Project Number: SP2019-007
Project Name: Lake Pointe Church
Project Type: SITE PLAN
Applicant Name: HALFF ASSOCIATES
Owner Name: LAKE, POINTE BAPTIST CHURCH
Project Description:

Type of Review / Notes	Contact	Sent	Due	Received	Elapsed Status	Remarks
With this Site Plan following an administrative review for a parking lot, the following staff comments are to be addressed prior to the release of any building permit						
The following staff comments are to be addressed and resubmitted at your convenience. These comments are considered to be conditions of approval. Please provide three large copies [24" X 36" FOLDED] and one PDF version for a subsequent/final review by staff:						
General Comments:

LAKE POINTE CHURCH
PARKING LOT EXPANSION
 701 Interstate 30 Rockwall, TX 75087

**SITE PLAN
LAKE POINTE CHURCH
PART OF LOT 3, BLOCK A
CITY OF ROCKWALL
ROCKWALL COUNTY, TEXAS
MARCH, 2019**

Project No.:	35866
Issued:	03.14.19
Drawn By:	MAW
Checked By:	KMW
Scale:	1:20
Sheet Title	TREESCAPE PLAN
Sheet Number	L1.01

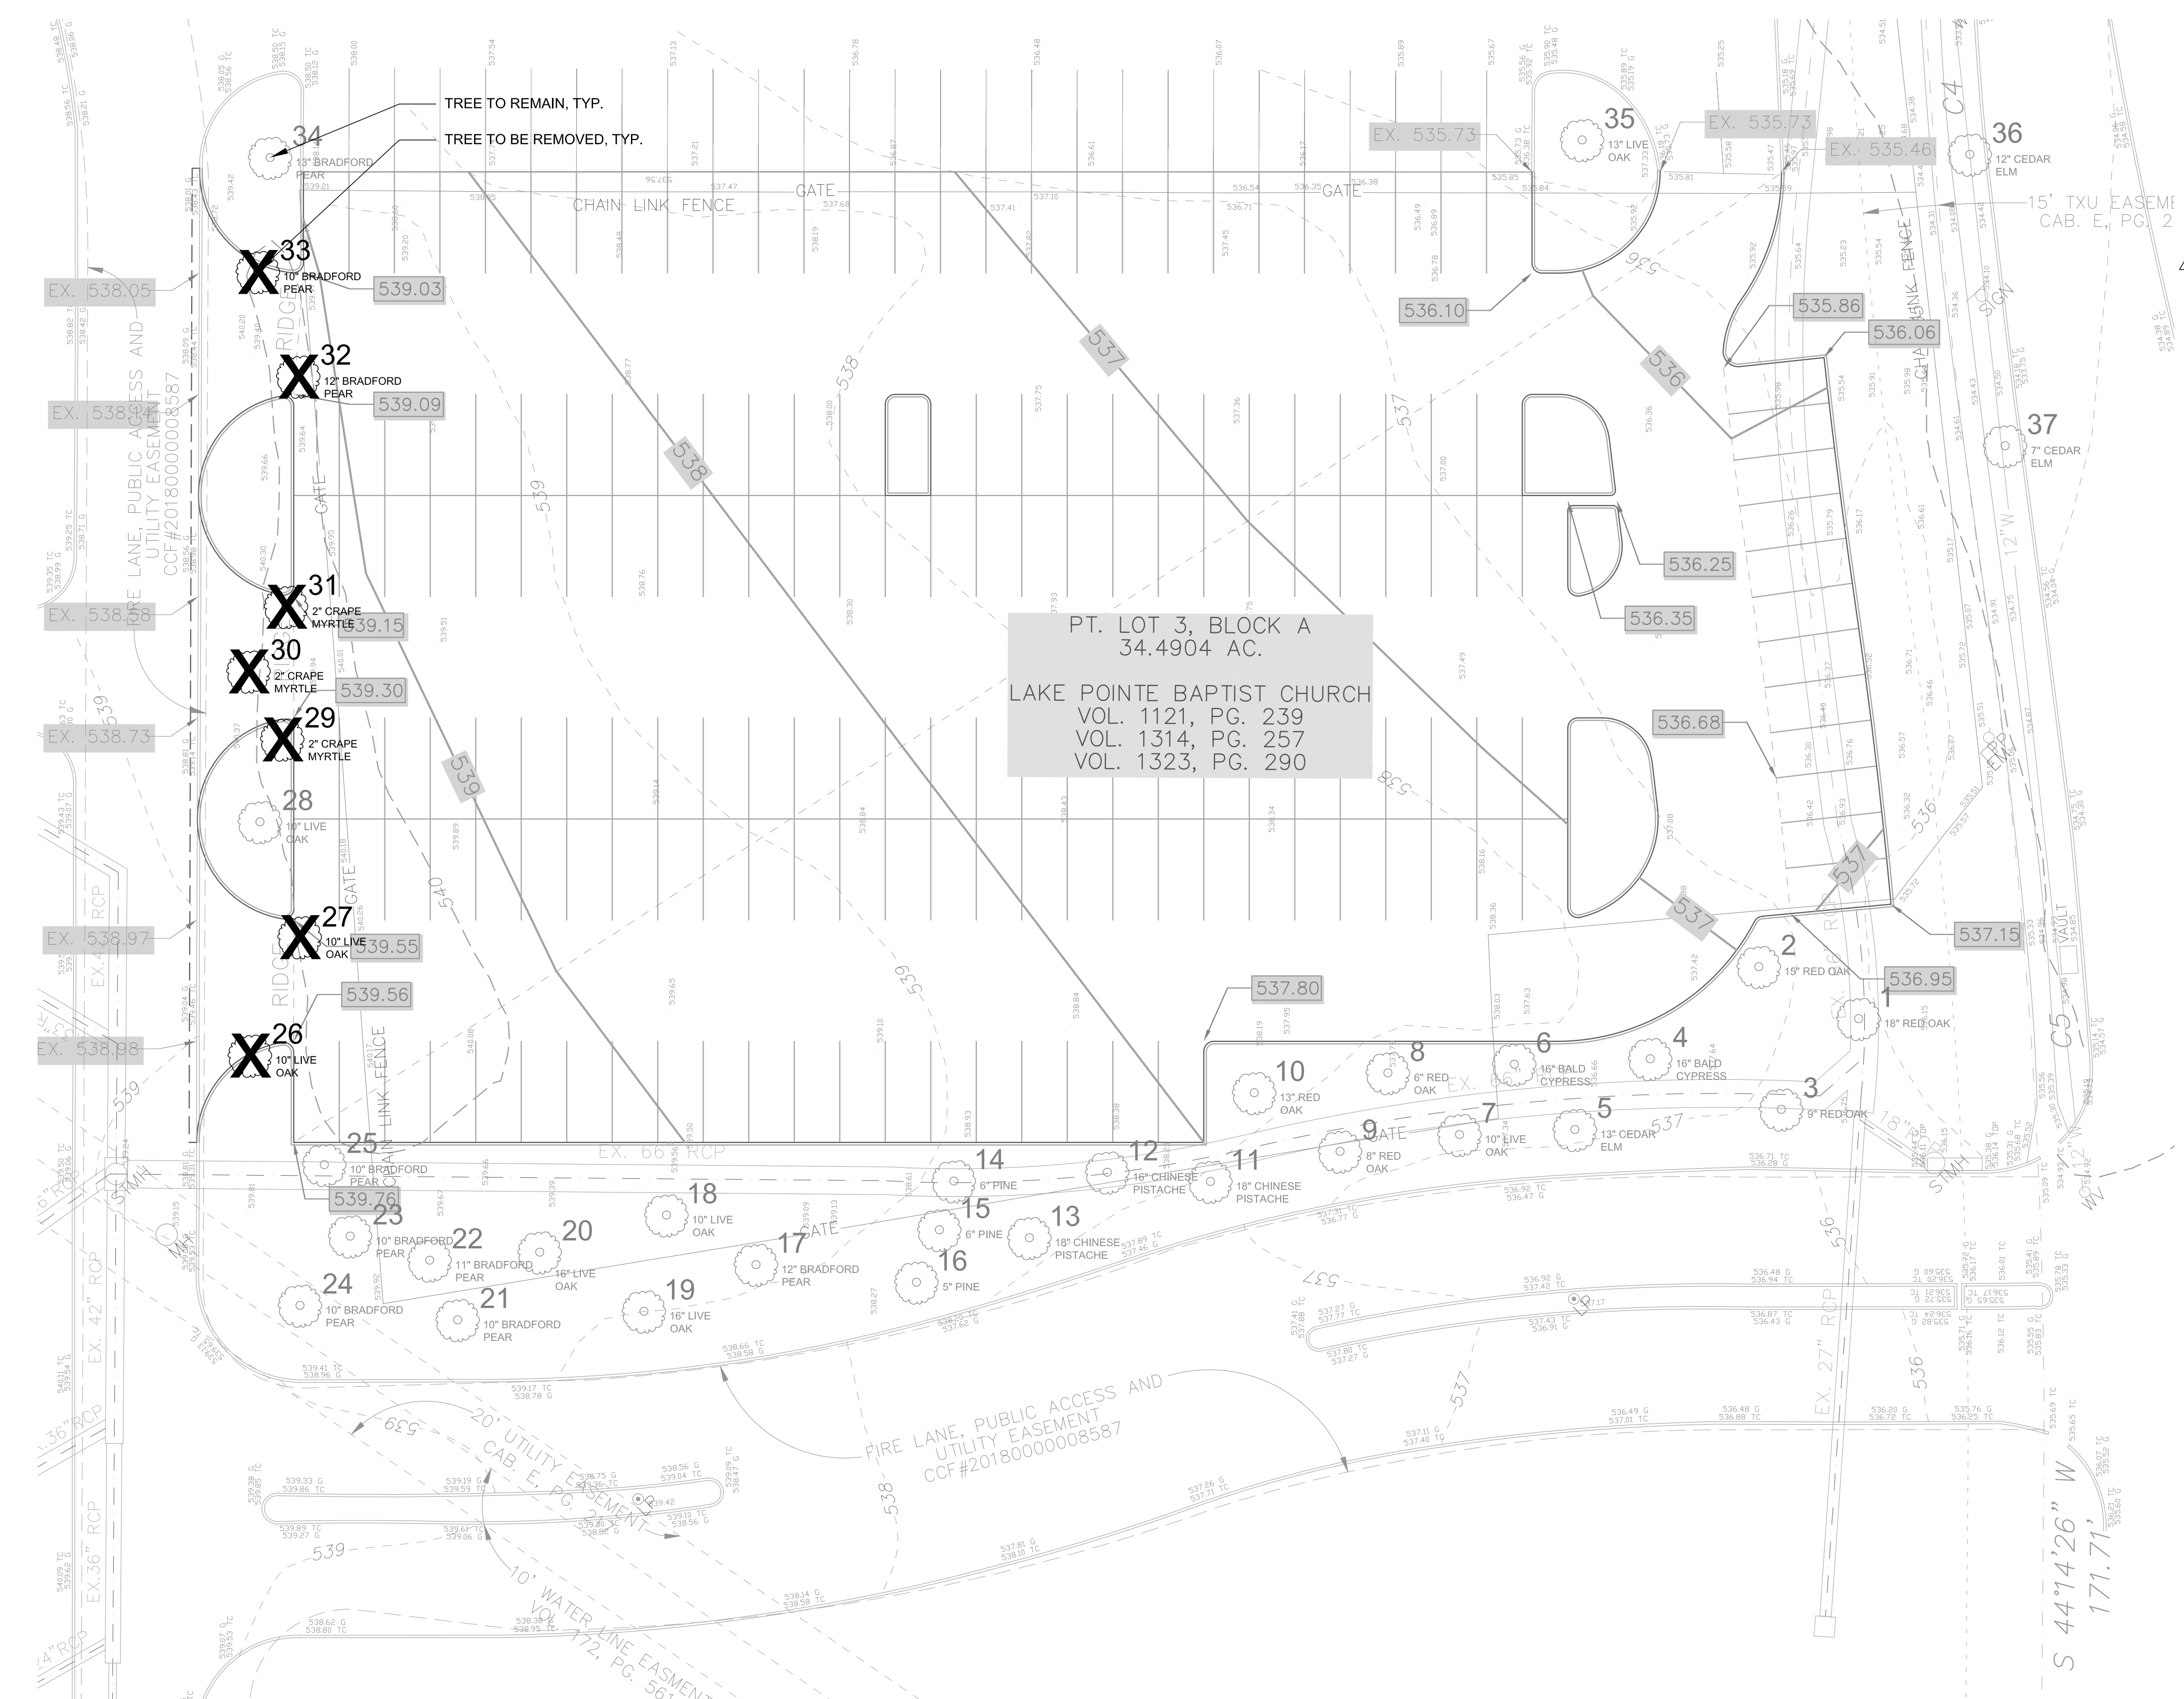
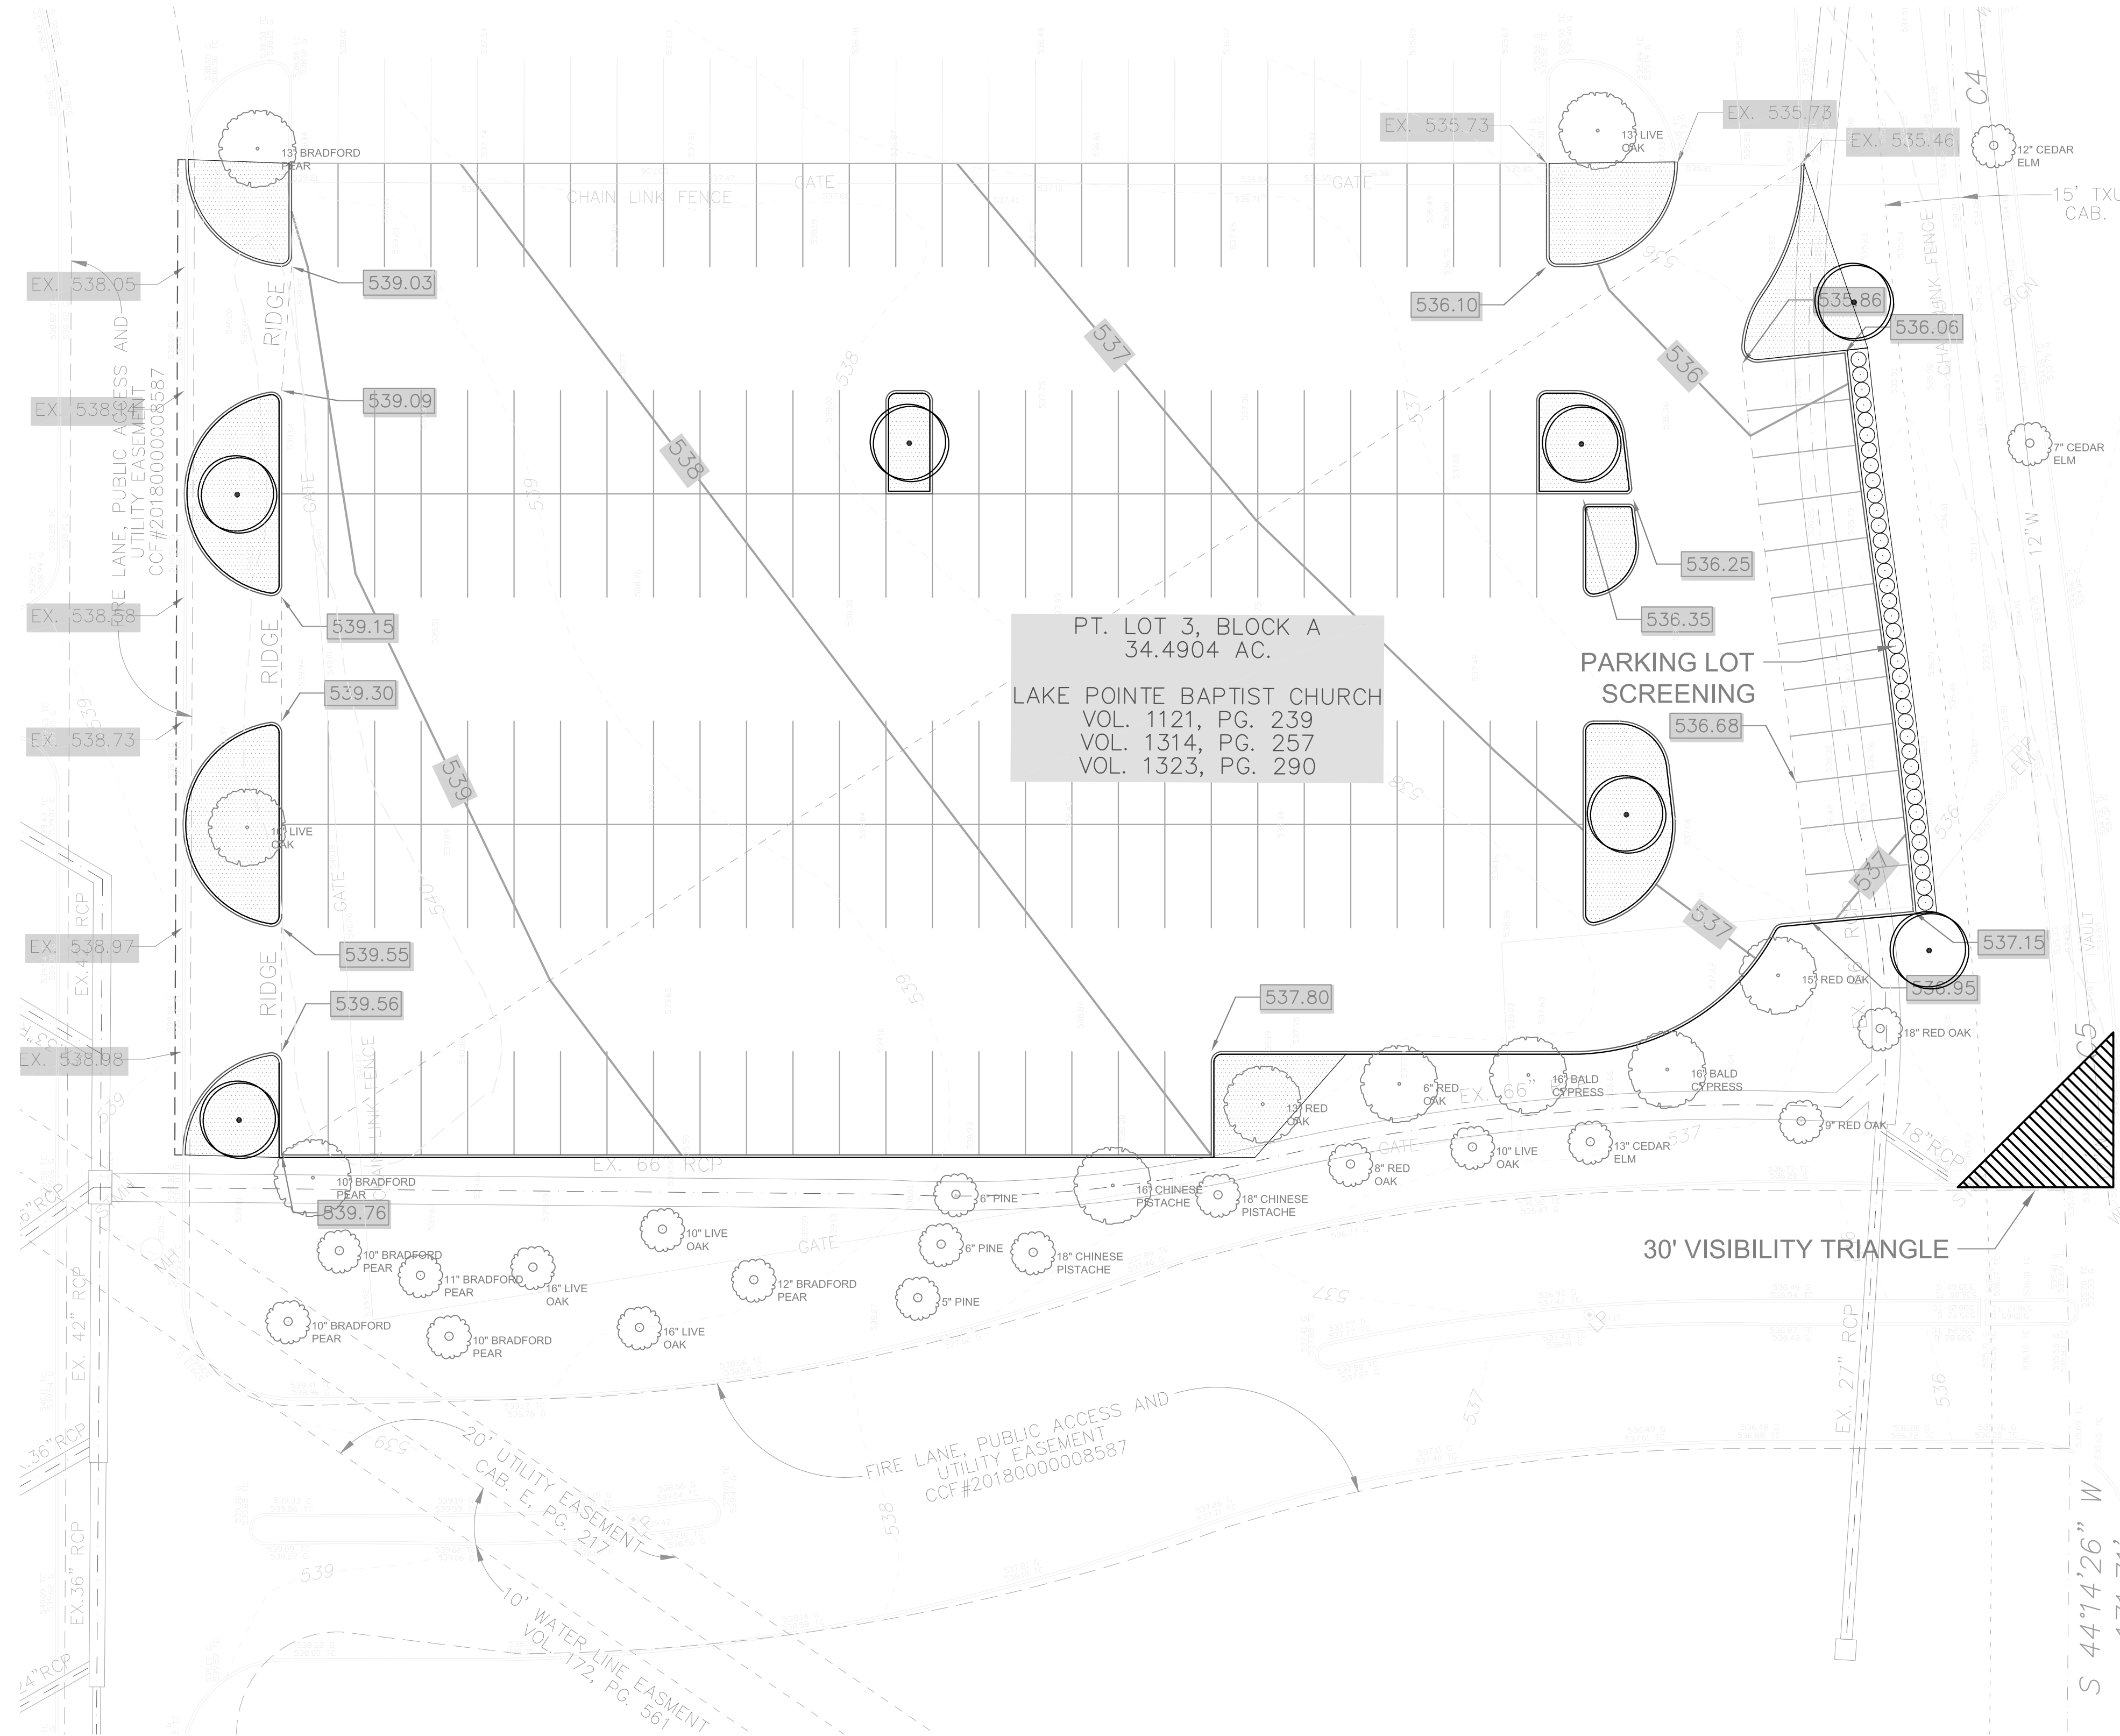
1. Sheet C1.02: Delineate and label existing sidewalk along Ralph Hall Parkway.						
Landscape Plan:						
1. Sheet L1.01: Ghost in all existing trees to better delineate new plantings for site.

Revision No.	Date	Description
1	03.22.2019	Notes, lighten tree symbols
